PIC18F6310/6410/8310/8410 Rev. B3 Silicon Errata

The PIC18F6310/6410/8310/8410 Rev. B3 parts you have received conform functionally to the Device Data Sheet (DS39635C), except for the anomalies described below. Any Data Sheet Clarification issues related to the PIC18F6310/6410/8310/8410 will be reported in a separate Data Sheet errata. Please check the Microchip web site for any existing issues.

The following silicon errata apply only to PIC18F6310/6410/8310/8410 devices with these Device/Revision IDs:

FIGURE 1: SCK PULSE VARIATION USING TIMER2/2

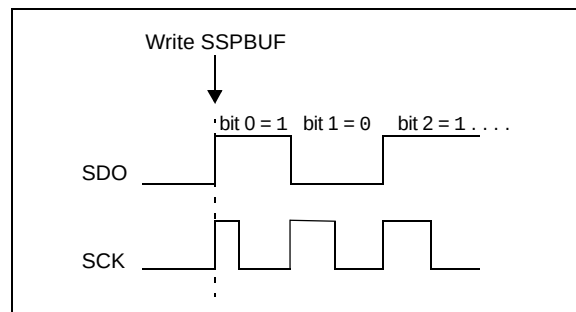
26. Module: MSSP (SPI Mode)

When the SPI is using Timer2/2 as the clock source, a shorter than expected SCK pulse may occur on the first bit of the transmitted/received data ([Figure 1](#)).

To avoid producing the short pulse, turn off Timer2 and clear the TMR2 register, load the SSPBUF with the data to transmit and then turn Timer2 back on. Refer to [Example 4](#) for sample code.
